11/17/01 Review of Dynamic soil properties from G(P018)-2

Soil Calculations for PFS
For CTB

11/19/01REVIEW OF STORAGE PAD ANALYSIS

Summary of Results from NUREG/CR-6608

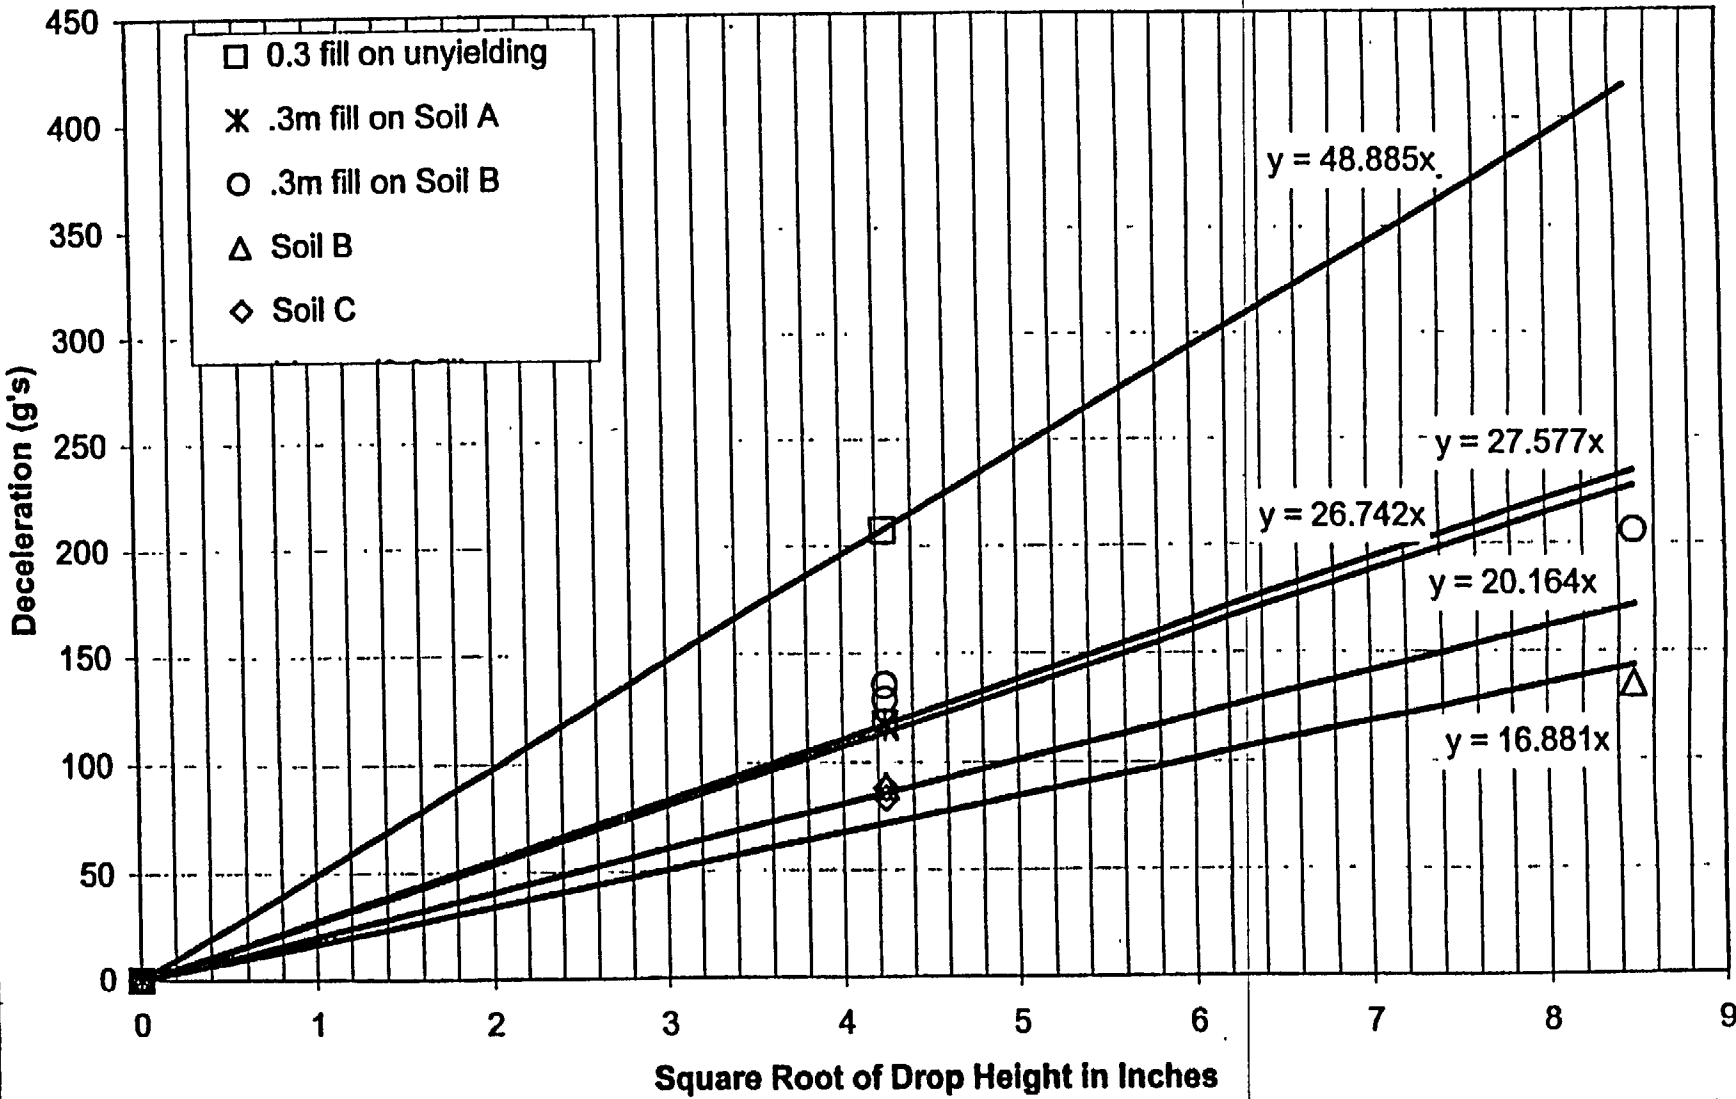
The test results were plotted using Microsoft Excel. The resulting data indicates that the peak deceleration is proportional to the square root of the drop height.

DJP 11/19/01 This corresponds to the fact that the deceleration is proportional to the energy of impact and the stiffness of the system.

A linear regression analysis of the data in NUREG/CR-6608 was performed and plotted (see page 17)

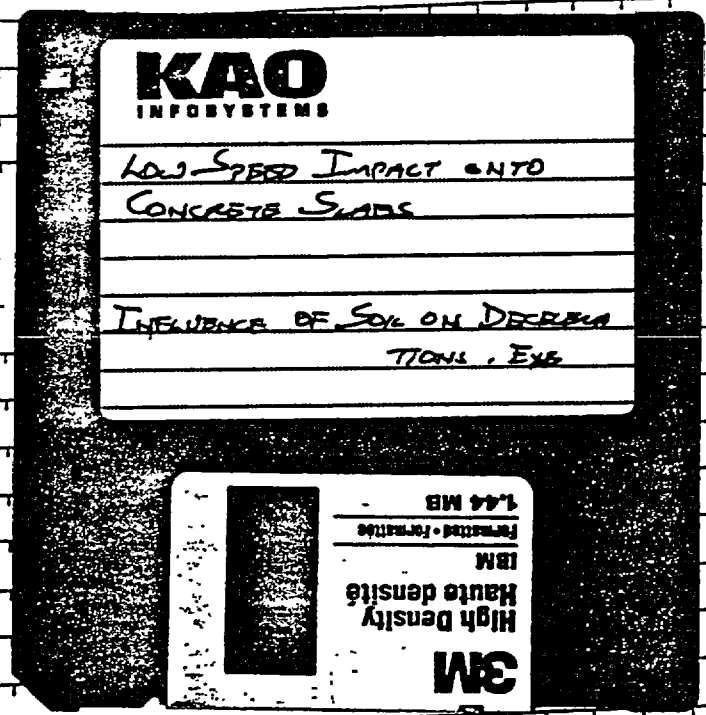
The data indicates that the deceleration for a specific impact ^{DIP 11/19/01} condition ~~that~~ is proportional to the square of the drop height. This correlates to the information provided on page 12 of Hottel HI-2012663 Revision 2.

There is a slight dependence on the type of soil.

There is more change due to the addition of engineered fill
